UNITED STATES PATENT AND TRADEMARK OFFICE

APPLICATION NO.	FILING DATE	FIRST NAMED INVENTOR	ATTORNEY DOCKET NO.	CONFIRMATION NO.
09/804,105	03/12/2001	Norbert A. Feliss	SJ0920000138US1	8988
48583	7590	06/29/2005	EXAMINER	
BRACEWELL & PATTERSON, LLP			MILLER, BRIAN E	
PO BOX 61389			ART UNIT	
HOUSTON, TX 77208-1389			PAPER NUMBER

Office Action Summary

FIG. 5

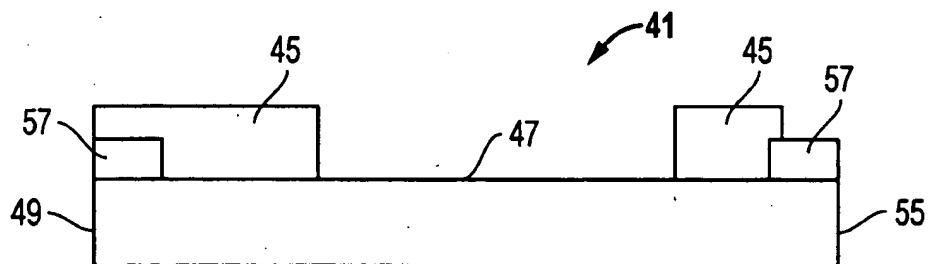
1. The new drawing sheet was received on 1/18/05. This drawing is acceptable.
